## BAKER'S ADDITION TO SNOW ROAD SUBDIVISION

APPLICATION NUMBER 9 DATE August 19, 2004

APPLICANT Baker's Addition to Snow Road Subdivision

REQUEST Subdivision

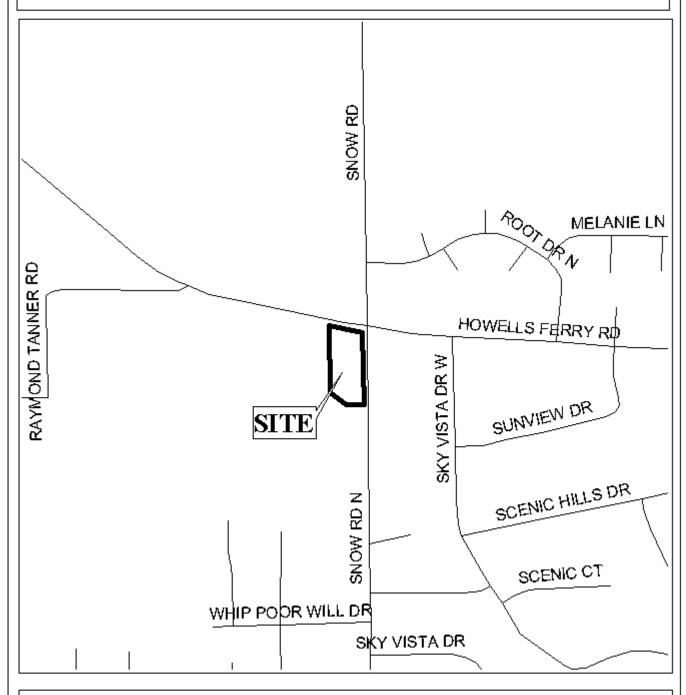
The site fronts Howells Ferry Road, which has an existing right-of-way of 80-feet, is a planned major street on the Major Street Plan, and as such requires a 100-foot right-of-way. Additionally, Snow Road has an existing right-of-way of 60-feet and is also a planned major street on the Major Street Plan, and as such requires a 100-foot right-of-way. Therefore, the dedication of sufficient rights-of-ways to provide 50-feet from the centerline of Howells Ferry Road and Snow Road should be required. Moreover, as a means of access management, a note should be placed on the final plat stating that the size, number and location of all curb cuts are to be approved by County Engineering.

Furthermore, with Lot 1 being a corner lot, the dedication of a 25' radius should be required.

This site is located in the County, thus a note should be placed on the final plat stating that any lots which are developed commercially and adjoin residentially developed property must provide a buffer, in compliance with Section V.A.7. of the Subdivision Regulations.

The plat meets the minimum requirements of the Subdivision Regulations and is recommended for Tentative Approval subject to the following conditions: 1) the dedication of sufficient rights-of-ways to provide 50' from the centerline of Howells Ferry Road and Snow Road; 2) the dedication of a 25-foot radius at the corner of Howells Ferry Road and Snow Road; and 3) the placement of a note on the final plat stating that any lots which are developed commercially and adjoin residentially developed property must provide a buffer, in compliance with Section V.A.7. of the Subdivision Regulations.
